Changes to product identification resulting from this PCN:

Package symbolization:

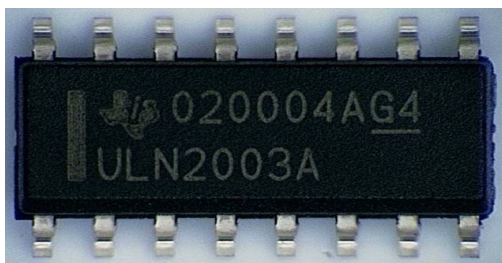
No Change to package level symbolization. Symbolization contains the recommended ECAT symbol in addition to TI Lot Trace Code and device name.

G4 = Green products with NiPdAu/Ag Lead Finish

G3 = Green products with Matte Sn lead finish.

Packing Label

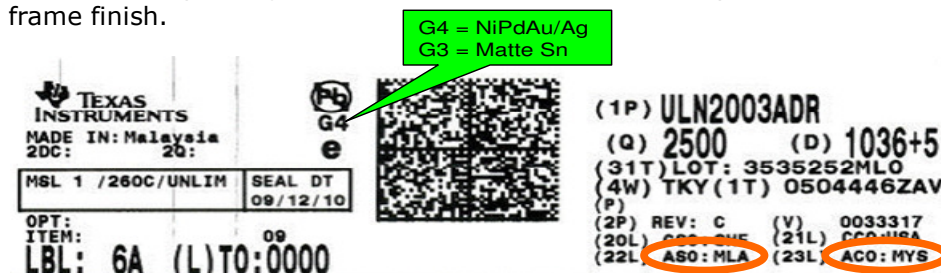
No change to TI Manufacturing Label and Customer Label (if applicable). Each reel, pizza boxes and standard packing boxes includes the correct ECAT symbols based on the appropriate lead frame finish.

Note: ASE-Shanghai will have the site code (ASO) and country of origin code (ACO) below.
